REQUEST FOR TECHNICAL REVISION (TR) COVER SHEET

Asphalt Paving Co., Ralston Quarry M-1974-086
Technical Revision – Modifications to Slide Repair Designs and Plans

**Limited Geotechnical Evaluation
Slope Stability and Remediation Approach
Ralston Quarry
Jefferson County, Colorado
Revised6**

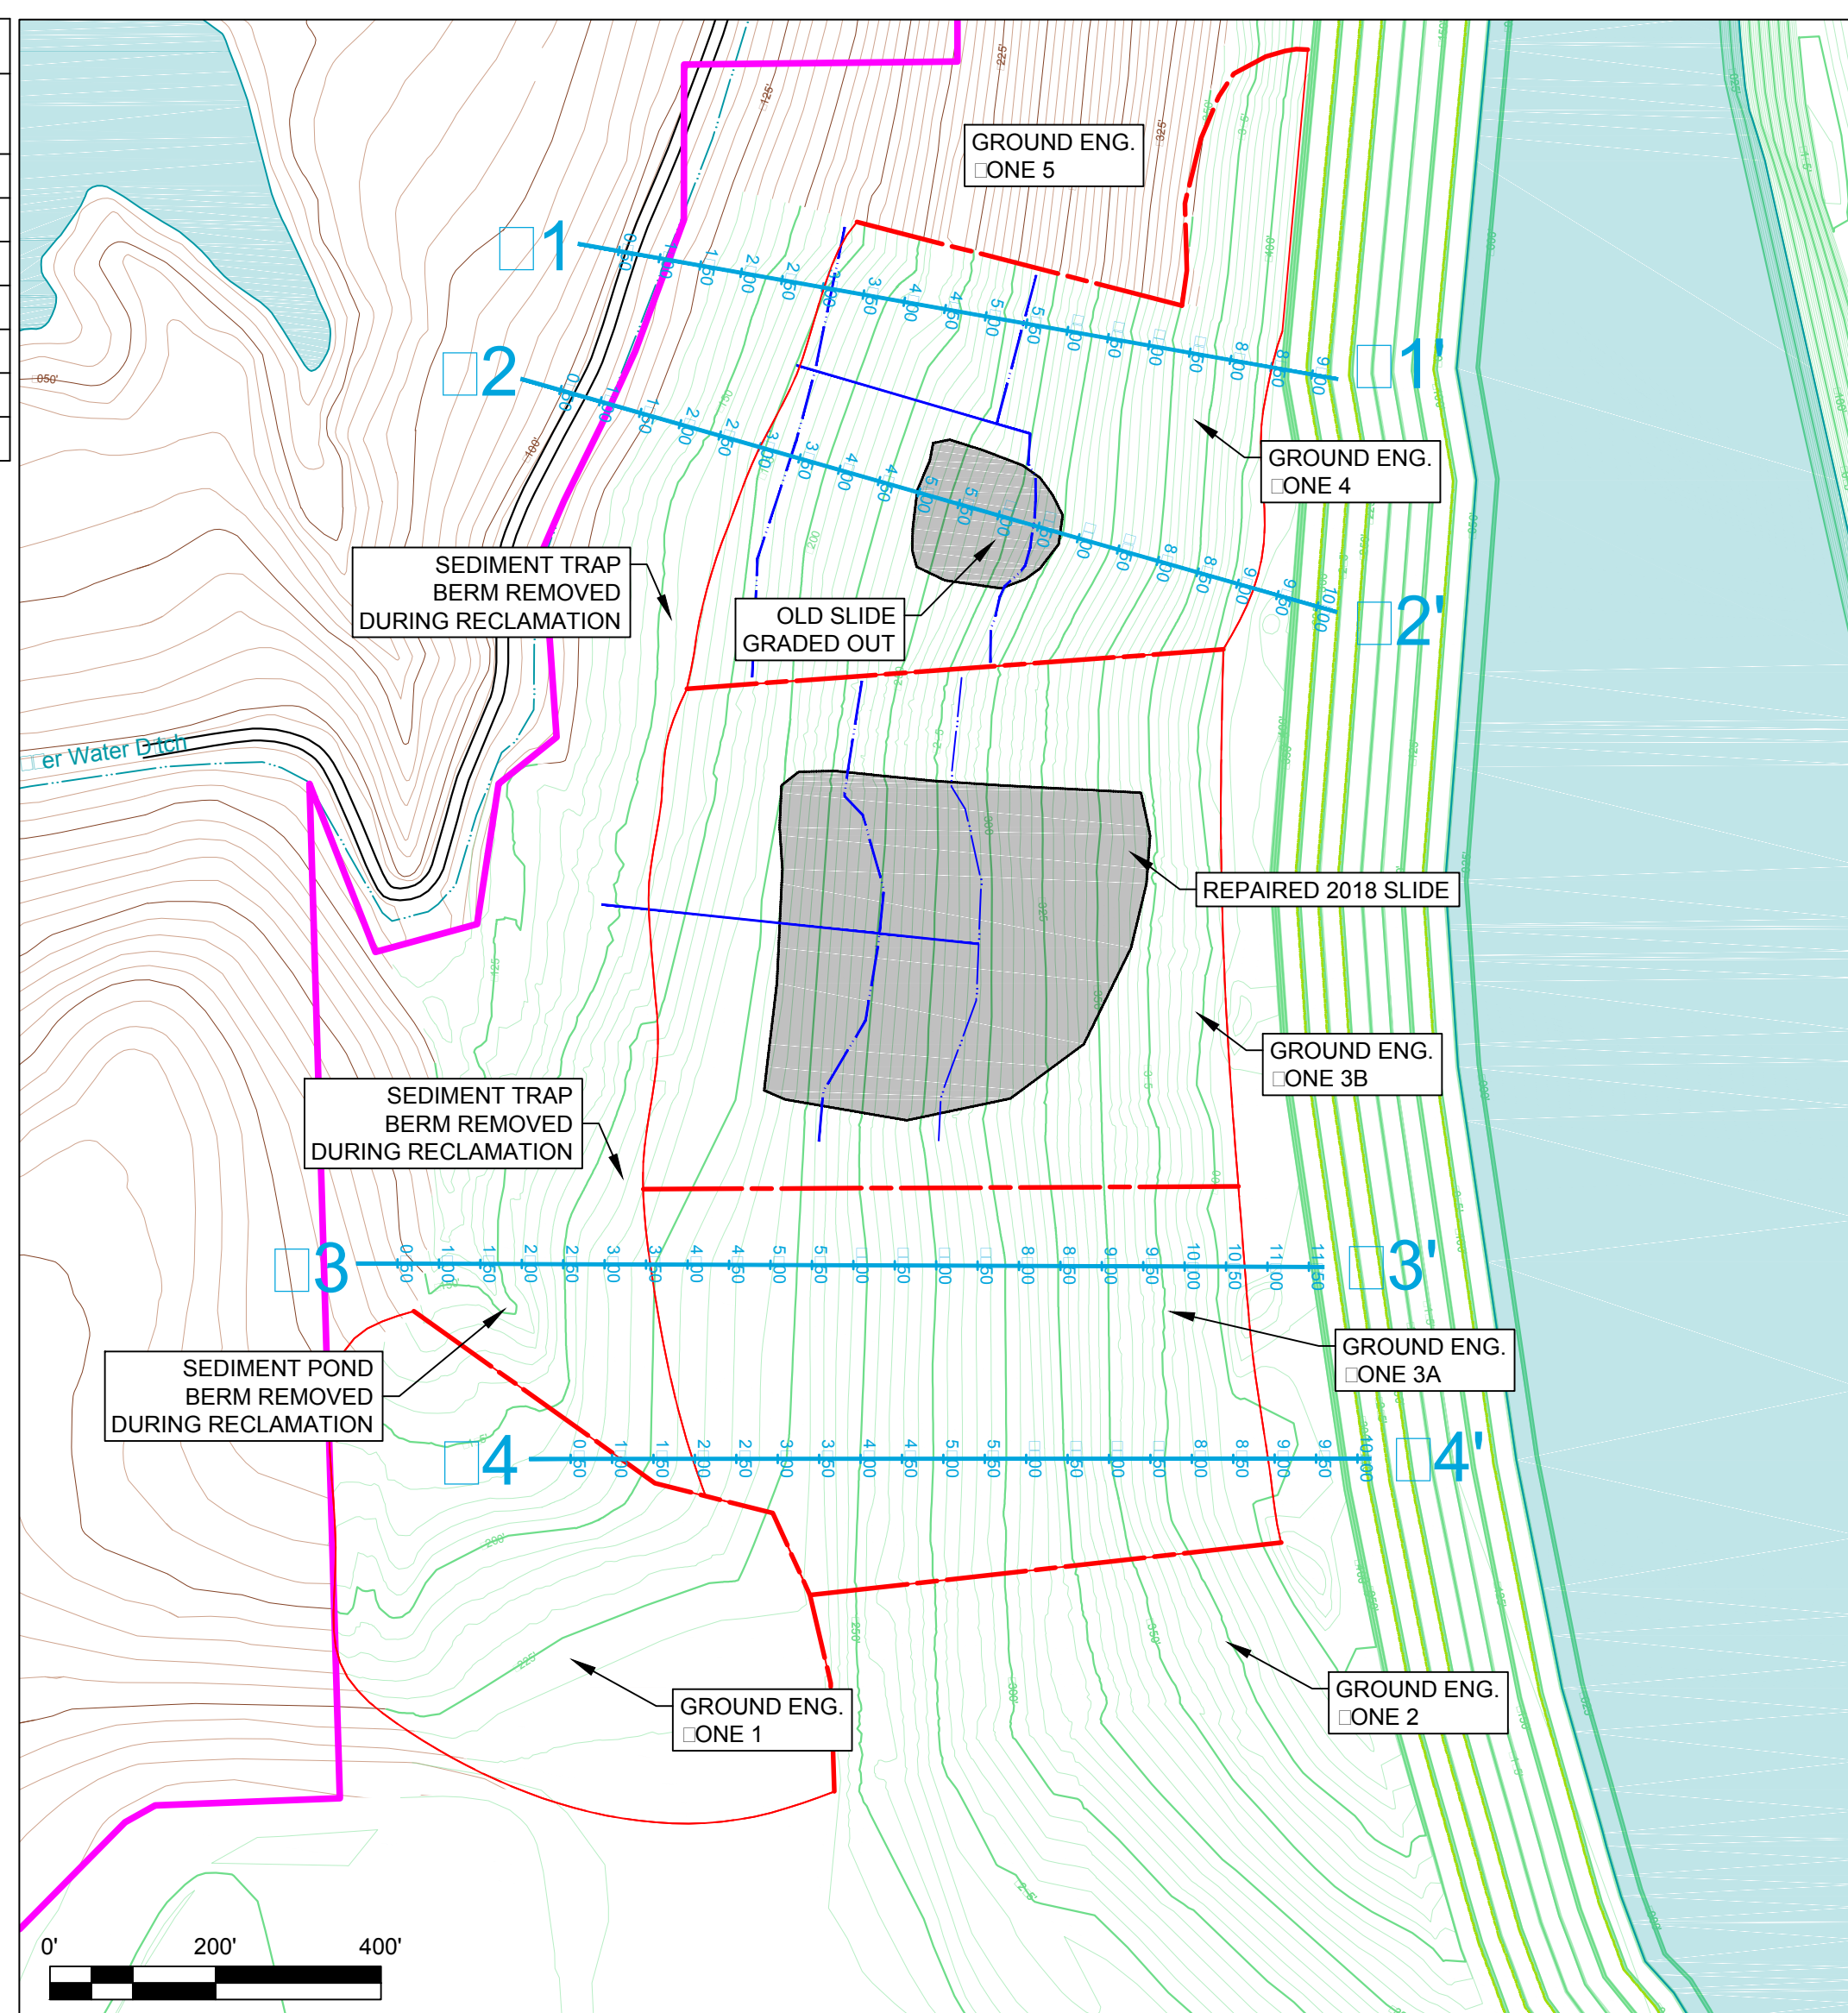
Zone 3 consists of the 2018 slide and surrounding ground. This area was evaluated in detail by Ground Engineering to determine the most effective and efficient way to accomplish slope stability without construction safety risk or unnecessary ground disturbance. Cross sections were developed perpendicular to the slope and different designs were evaluated along these cross sections in an iterative process to determine the appropriate repair design. Ground Engineering's attached report shows the slope stability that is achieved with these designs. Map F-2 shows the existing and final slope cross sections.

Zone 3A will not require the installation of subsurface drains, as regrading of this section of slope will be sufficient to achieve a safety factor of 1.3. Two cross sections through this area were analyzed and can be seen on Map F-2.

Zone 4 consists of areas north of the 2018 slide that contain a previous, smaller slide area. This area was evaluated in detail by Ground Engineering to determine the most effective and efficient way to accomplish slope stability without construction safety risk or unnecessary ground disturbance. Cross sections (X1-X1' and X2-X2' on Map F-2) were developed perpendicular to the slope and different designs were evaluated along these cross sections in an iterative process to determine the appropriate repair design. Ground Engineering's attached report shows the slope stability that is achieved with these designs is 1.4 and 1.2. Map F-2 shows the existing and final slope cross sections.

Subsurface drainage systems will be installed in this zone. Their arrangement can be seen on Map F-2.

Map C-4 and F-2 show the revised subsurface pipe locations. None of the stormwater designs on Map C-4 have been changed from the approved permit designs.
